ERRATUM: ANALYSIS OF A CONTROLLER-BASED ALL-DIGITAL PHASE-LOCKED LOOP

[Published in Volume 15, Number 1 (2015)

Pages 57-73 of the

Far East Journal of Electronics and Communications]

Figure 5. (a) Frequency step of the reference clock, (b) ADPLL output frequency response with frequency division ($N = 32$) for the reference frequency step, and (c) step responses of $H_{\text{cln}}(z)$ and $H_{\text{cln}}(s)$ with the extracted simulation parameters.

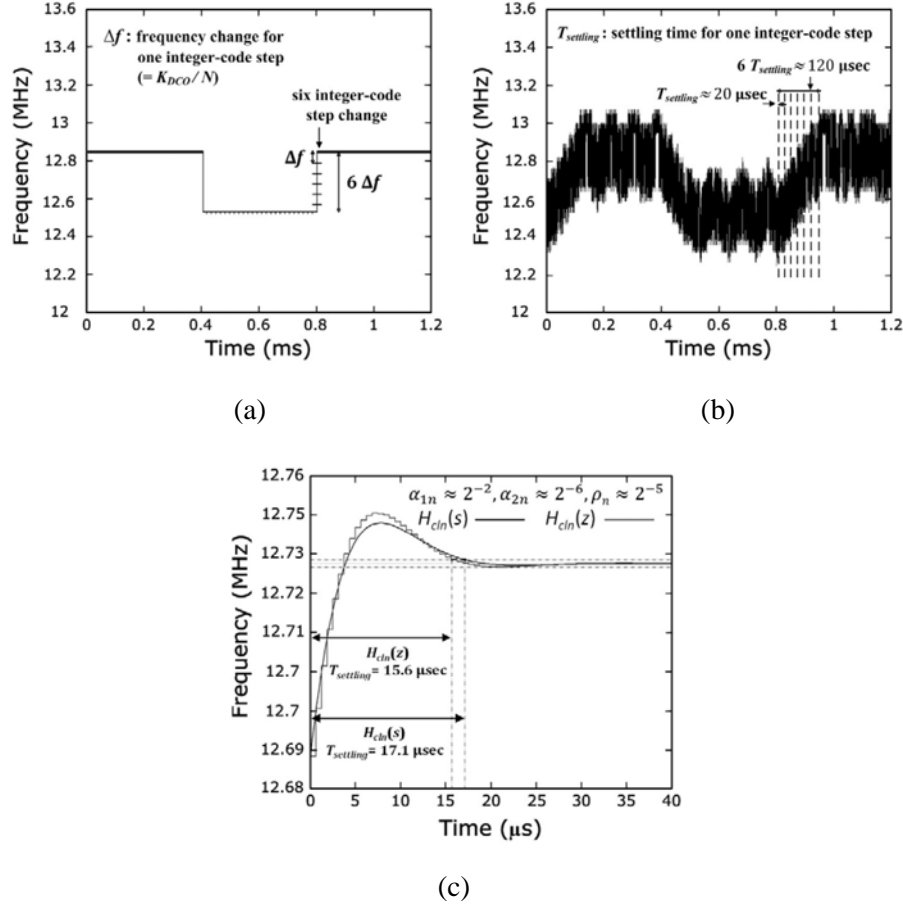
This paper was published online in July, 2015 [Volume 15, Number 1, Pages 57-73]. In this paper, we performed modeling and analysis of a controller-based all-digital phase-locked loop (ADPLL). However, we made a mistake in the calculation of the step response of the ADPLL to validate the model using behavior-level simulation.

The following sentences in the pages 69, 70, 71 should be corrected and Figure 5 should be replaced as follows.

The corrected Figure 5 is shown as below.

Page 70, line 1: "... code with time to reduce the phase error is shown in Figure 4(c) as decimal variation. Figure 5(a) shows the frequency step of the reference clock corresponding to a step change of six DCO integer-code, which can show enough change in ADPLL output frequency over frequency variation. By considering this large frequency step as combination of small one integer-code step, the small-signal approximation used in equations (3) and (4) can still be validated. As shown in Figure 5(b), the output frequency settling to a step change of one integer-code is around 20μsec. The K_{DCO} from simulations is about 1.6MHz/code change ($= 3.2\pi$ Mrps/code change), and the K_{PPF+PI} is $2\pi/64$ for the 64-phase..."

Page 71, line 10: "... settling times of 15.6μsec and 17.1μsec which are close to the settling time simulated using the behavior-level simulation ($T_{\text{setting}} \approx 20\mu\text{sec}$)".
